**STAFF REPORT - TOWN OF NORTH CASTLE PLANNING DEPARTMENT**

APPLICATION NUMBER - NAME  
 #2023-014 – 32 Orchard Drive Subdivision,  
 Steep Slope Permit and Tree Removal Permit  
 Applications

**Five lot subdivision of a 12.9 acre lot located in the R-2A Zoning District with proposed well and septic. Proposal is for the existing house to remain and to develop four additional single family homes.**

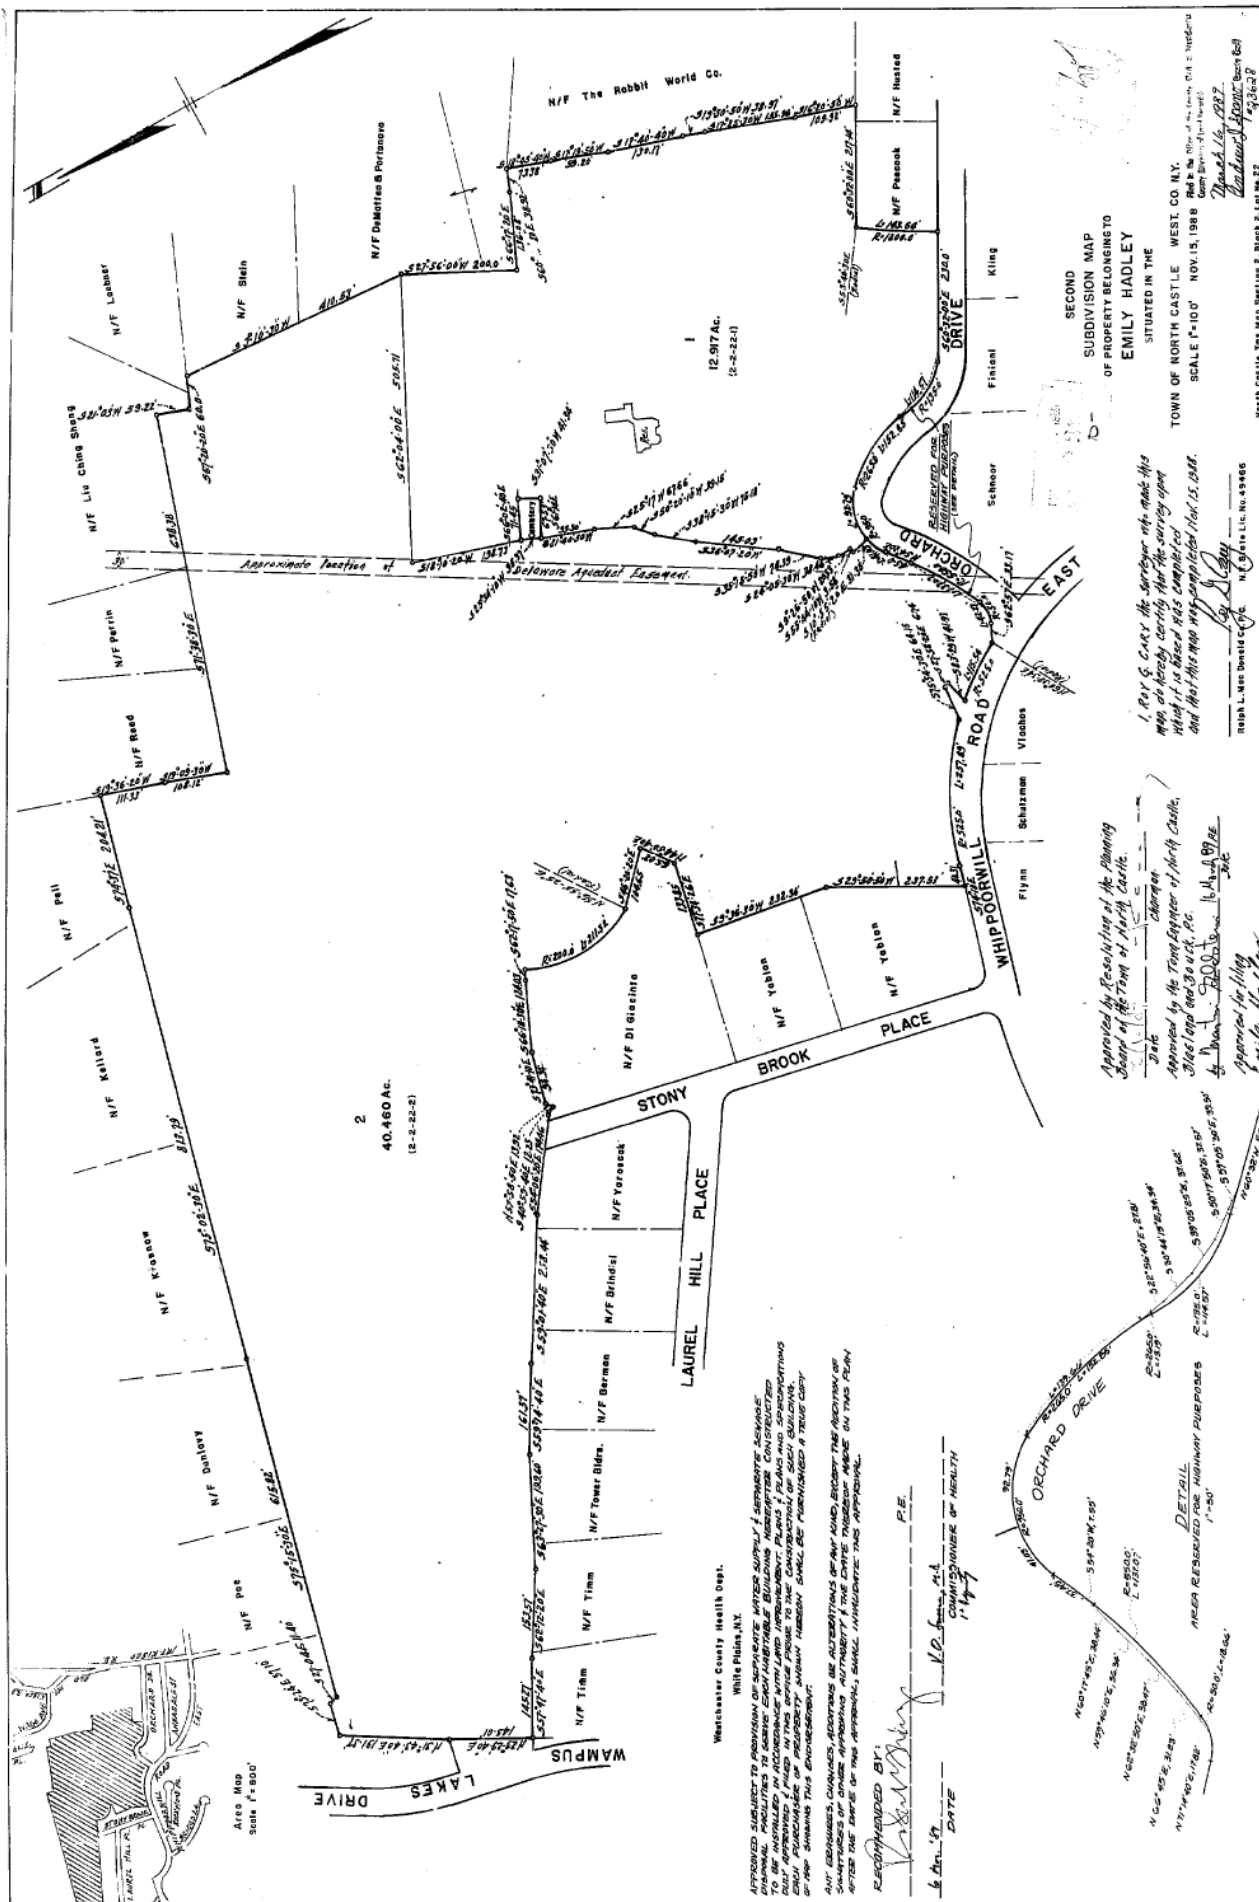
<p><u>General Comments</u></p> <ol style="list-style-type: none"> <li>1. Pursuant to Section 275-23, Section 255-14.G and Section 355-21 of the Town Code, Lot 3 is required to have frontage on an improved street. The Applicant will need to provide frontage on a roadway to the satisfaction of the Planning Board and Town Engineer.</li> <li>2. The Applicant is proposing two curbcuts in close proximity to each other. The proposed condition will not be aesthetically appropriate and may create additional difficulty providing snow plowing and highway maintenance. It is recommended that a single curbcut along Orchard Drive be provided for all of the lots in the subdivision. If a single curbcut is not possible, perhaps the driveway serving Lot 5 could be relocated – this would improve aesthetics, snow management and would improve sight distance at the driveway.</li> <li>3. Pursuant to Section 275-25 all new streets should be provided with pavement, sidewalks, curbs, gutters, streetlighting, signs, trees, storm drains, fire alarm devices, fire hydrants and other utilities, except that the Planning Board may waive such improvements as it considers not requisite in the interest of the public health, safety and welfare. Given the location of the proposed subdivision and the lack of available infrastructure, it is recommended that the Planning Board waive the following: sidewalks, streetlights, street trees, fire alarm devices and fire hydrants.</li> <li>4. The house is proposed to remain on Lot 2. The Applicant will need to demonstrate conformance with all zoning requirements pursuant to Section 355-14.C of the Town Code. Specifically, the Applicant should submit a gross land coverage calculations backup exhibit and a gross floor area calculations worksheet and backup information for this lot.</li> <li>5. The property contains Town-regulated trees. The Applicant should submit a tree plan that depicts the location of all Town-regulated trees and depicts proposed removal/preservation of Town-regulated trees. In addition, the plan should be accompanied by a Tree Survey that identifies the size, species and removal status of Town-regulated trees. The Applicant should attempt to preserve as many trees as possible within the subdivision. It is recommended that the submitted IPP include proposed clearing and grading limit lines to clarify the location of anticipated impacted areas.</li> <li>6. The property contains Town-regulated steep slopes. The plan should quantify, in square feet, the proposed amount of Town-regulated steep slope disturbance.</li> <li>7. The Applicant should submit an impact analysis matrix for the subdivision that includes total disturbance, steep slope disturbance, cut/fill and tree removal for each lot and the road right-of-way. The plans should be refined to depict potential grading associated with proposed houses and mowed/graded yard areas; these areas should be included in the impact matrix.</li> <li>8. The applicant shall submit payment of the recreation fee in the amount of ten-thousand dollars (\$10,000) for each new building lot, for a total of \$40,000 as stated in Section 275-27 of the Town Code.</li> </ol>	<p>The Applicant may wish to pursue an Open Development Area from the Town Board pursuant to Section 280-A of New York State Town Law.</p>

9. As noted in the property history section of this report, the property abuts the Townsend burial ground. It is requested that the Applicant provide an access easement to this burial ground from a public road. In addition, is recommended that the Applicant reach out to Town Historian Sharon Tomback to discuss this cemetery

It is noted, that any proposed easement should be accessed from the subject property and not Stony Brook Way, as the public does not have any access rights to Stony Brook Way.

10. Based upon the answer to question 12 of the submitted EAF, the Applicant should perform a Phase 1A archeological survey. Depending upon the results of the Phase 1A study, the Applicant may be required to conduct a Phase 1B reconnaissance survey.

The Applicant has indicated that they would provide an easement over Lot 3, from Stony Brook Way to access the cemetery.
